*** APPLEBY GO MTSA**
RECOMMENDED PREFERRED PRECINCT PLAN
 December 2021

ALDRESHOT GO MTSA RECOMMENDED PRELIMINARY PREFERRED PRECINCT PLAN December 2021

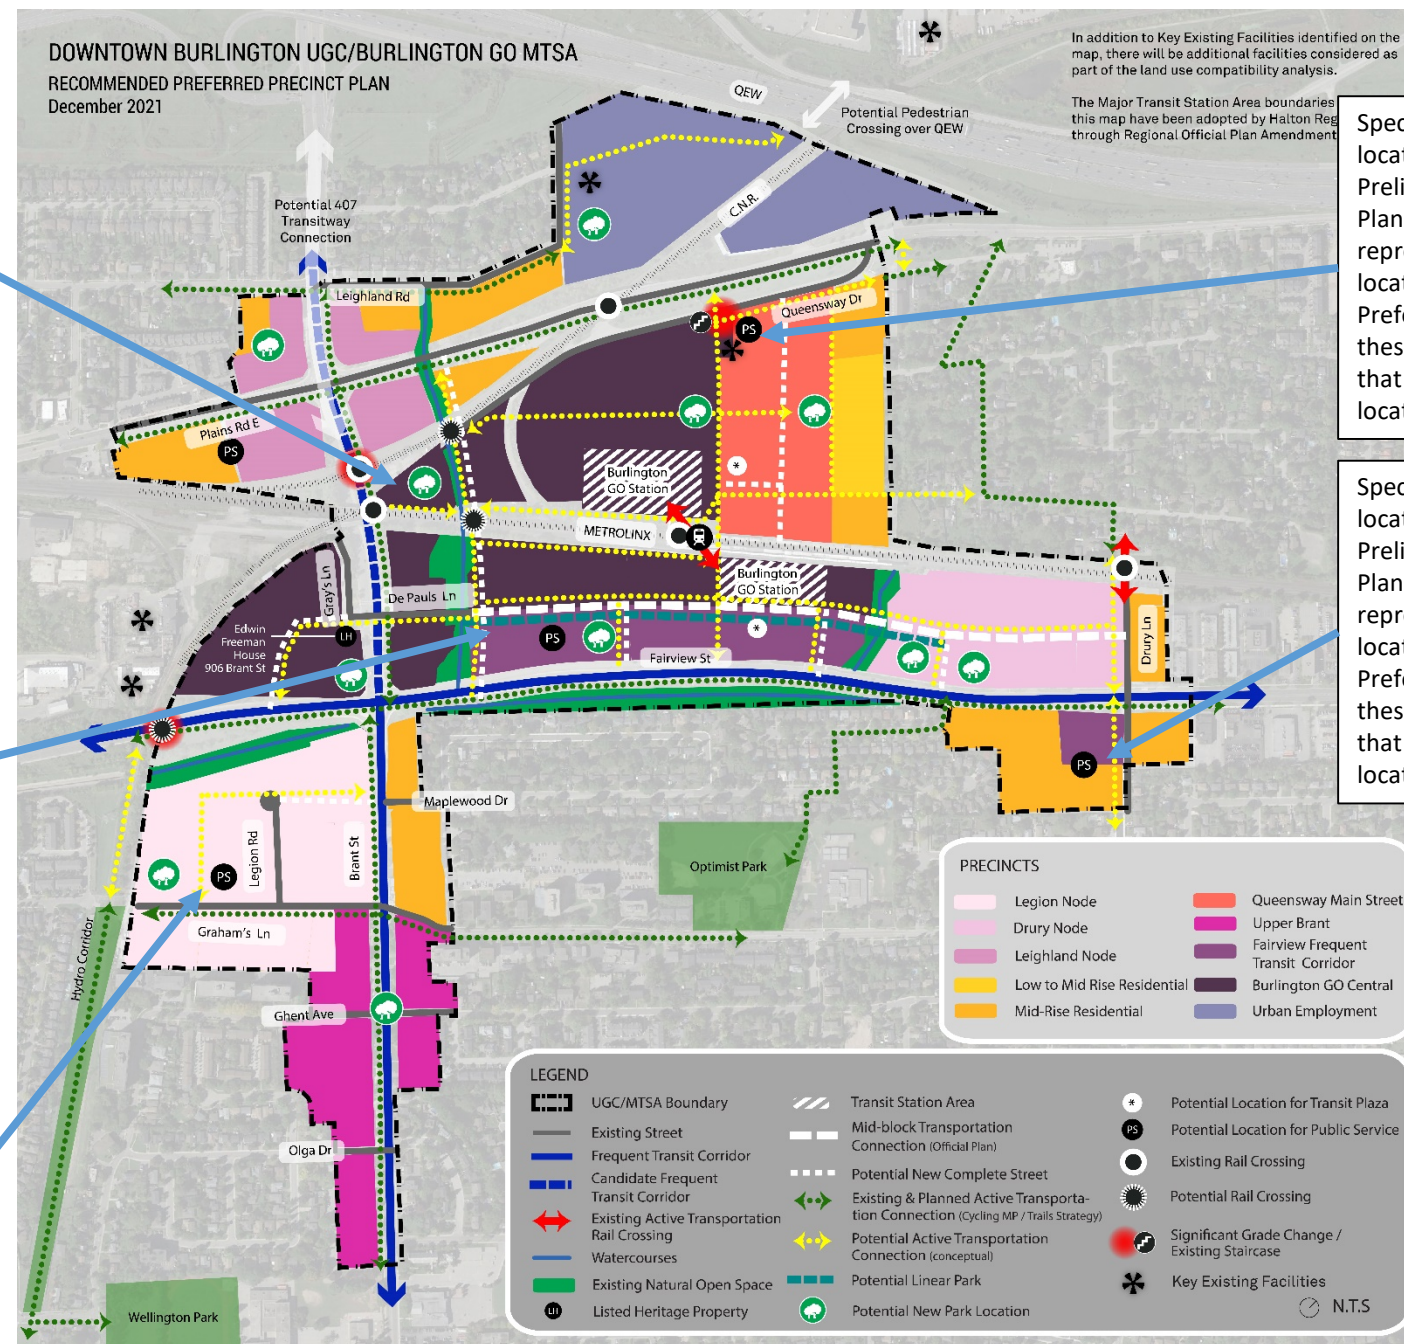
Irregular shaped lots on the northern side of the Metrolinx rail corridor which straddle the watercourse were initially identified as Mid-Rise Residential. It was thought that due to its location and how it was sitting in the middle of the Burlington GO Central precinct that it should all just become part of that precinct. There is also the potential to add a public open space as well as an active transportation connection through the parcel as well.

It was noted that linear parks should be on the north side of the street to minimize shadows. This change was made where possible; however the linear park along the mid-block transportation connection was left on the south side of the street to reflect potential that it can be integrated into proposed development.

Specific public service facility locations were noted on the Preliminary Preferred Precinct Plans. These were meant to represent potential locations. The Recommended Preferred Precinct Plan includes these locations but also notes that these facilities could be located in any precinct.

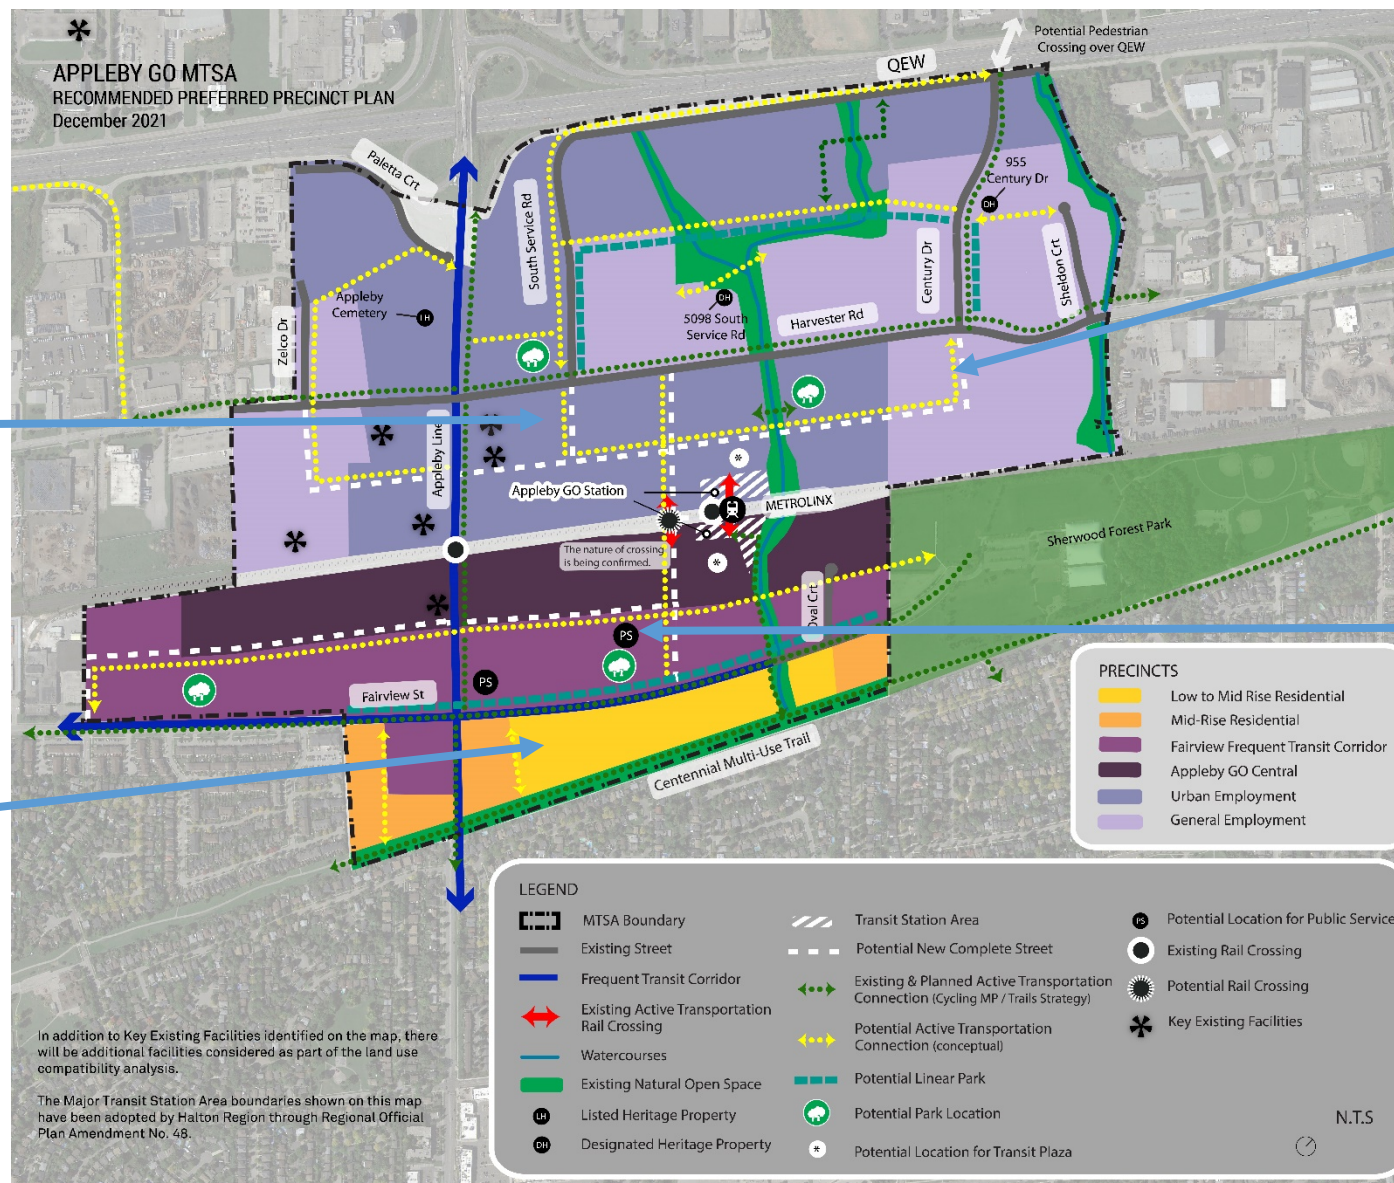
Specific public service facility locations were noted on the Preliminary Preferred Precinct Plans. These were meant to represent potential locations. The Recommended Preferred Precinct Plan includes these locations but also notes that these facilities could be located in any precinct.

Specific public service facility locations were noted on the Preliminary Preferred Precinct Plans. These were meant to represent potential locations. The Recommended Preferred Precinct Plan includes these locations but also notes that these facilities could be located in any precinct.

Potential new active transportation connections from the South Service Road westward to Appleby (north of existing gas station/drive through restaurant access).

Many members of the public noted that there are existing low-rise residential neighbourhoods south of Fairview Street within the MTSA. The Recommended Preferred Precinct Plan acknowledges that these lands are less likely to be re-developed within the time frame of the ASP and will be denoted by a new precinct: Low to Mid Rise Residential.

Questions were raised on whether streets shown on the Preliminary Preferred Precinct Plan that did not also include the symbol for an existing/planned or potential active transportation corridor would also include cycling and pedestrian opportunities. The Recommended Preferred Precinct Plan has been revised to clarify that all streets will have some complete streets elements.

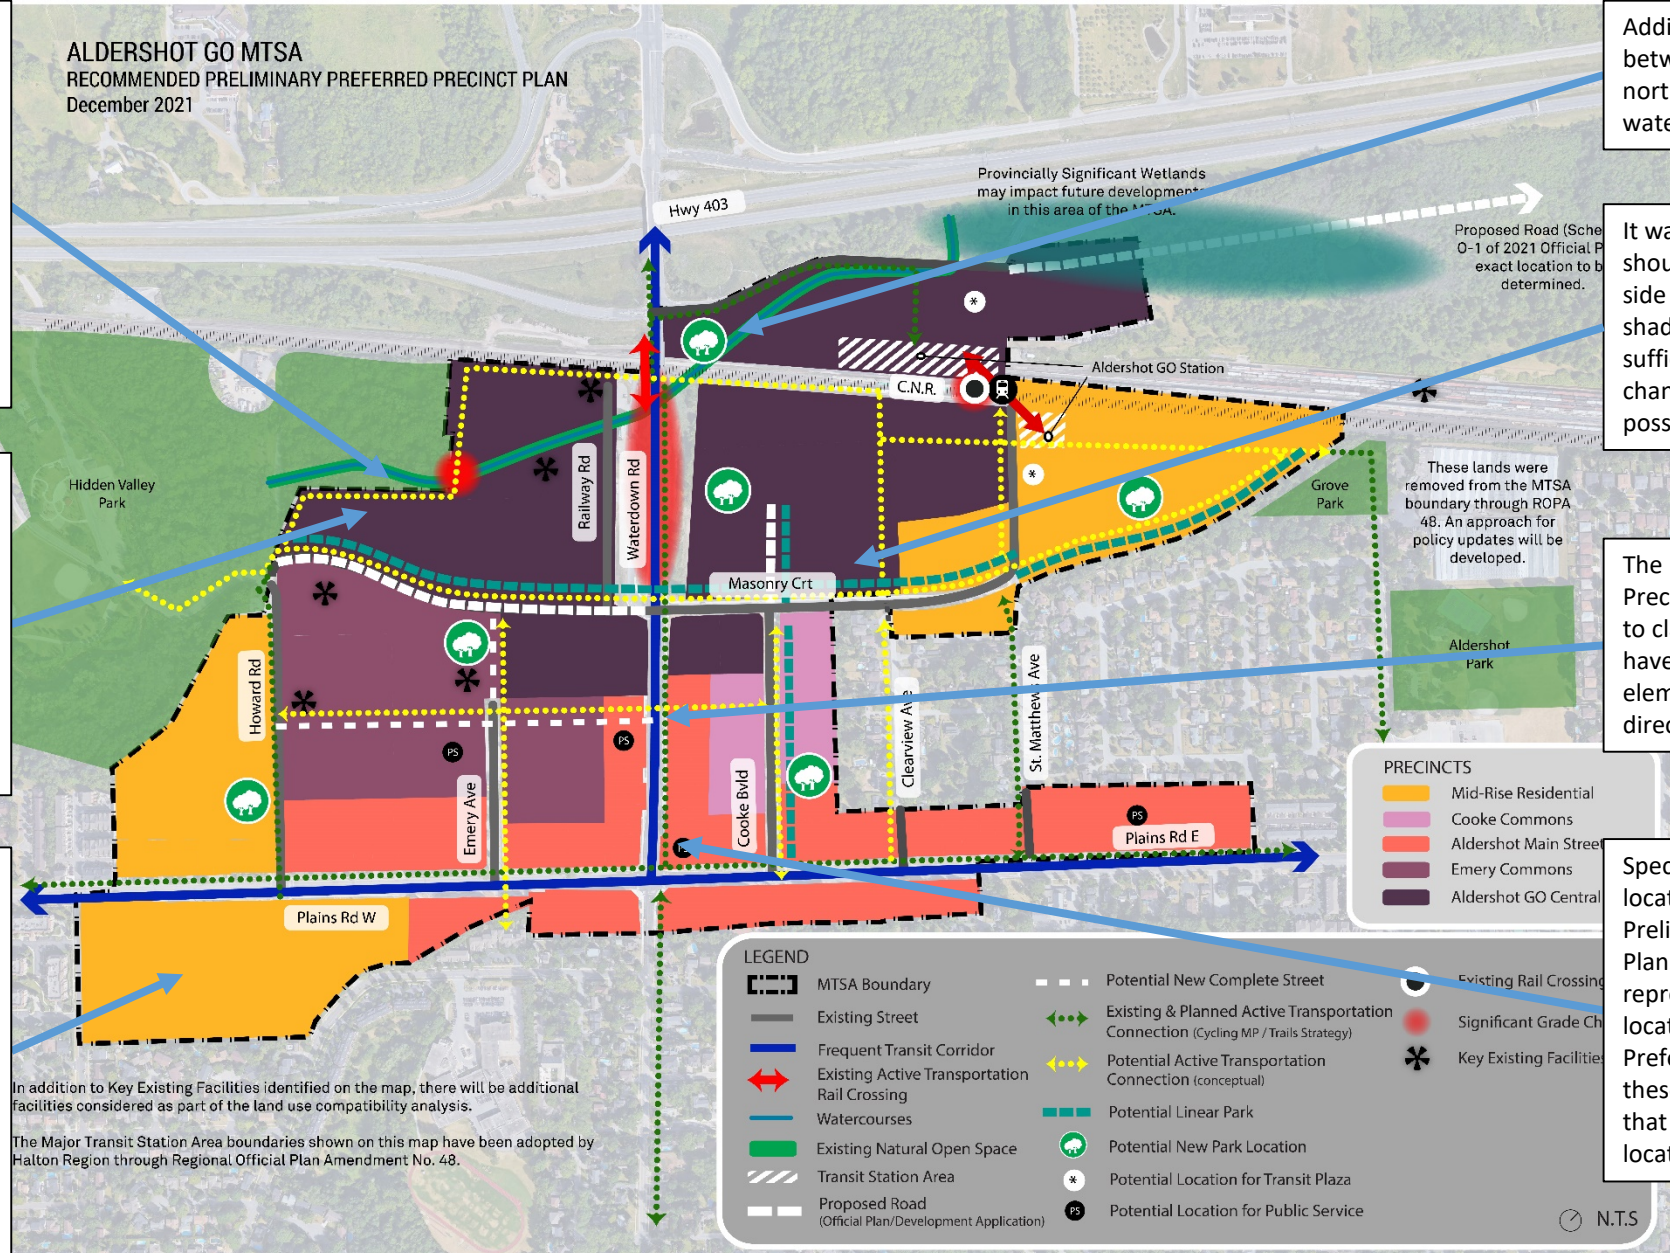
Specific public service facility locations were noted on the Preliminary Preferred Precinct Plans. These were meant to represent potential locations. The Recommended Preferred Precinct Plan includes these locations but also notes that these facilities could be located in any precinct.

The location of the potential active transportation trail in the northwest section of the Aldershot GO MTSA was reviewed to determine if there would be sufficient space to accommodate a trail in this location. As a result, the trail was shifted closer to the property line to accommodate development and provide a buffer to green open space.

The area north and west of Masonry Court was identified as a mid-rise residential area in the Preliminary Preferred Precinct Plan. Given that these lands are isolated from other mid-rise areas it was determined that these should be incorporated into the GO Central Precinct.

Many members of the public noted that there are existing townhouses and tall building developments located south of Plains Road West at the west end of the Aldershot GO MTSA. The Recommended Preferred Precinct Plan acknowledges that these lands are less likely to be redeveloped within the lifespan of this plan.

Addition of potential park space between Waterdown Road, northern boundary and watercourse.

It was noted that linear parks should be located on the north side of the street to minimize shadows and allow trees sufficient sunlight to thrive. This change was made where possible throughout the plan.

The Recommended Preferred Precinct Plan has been revised to clarify that all streets will have some complete streets elements, in alignment with the direction of the IMP.

Specific public service facility locations were noted on the Preliminary Preferred Precinct Plans. These were meant to represent potential locations. The Recommended Preferred Precinct Plan includes these locations but also notes that these facilities could be located in any precinct.
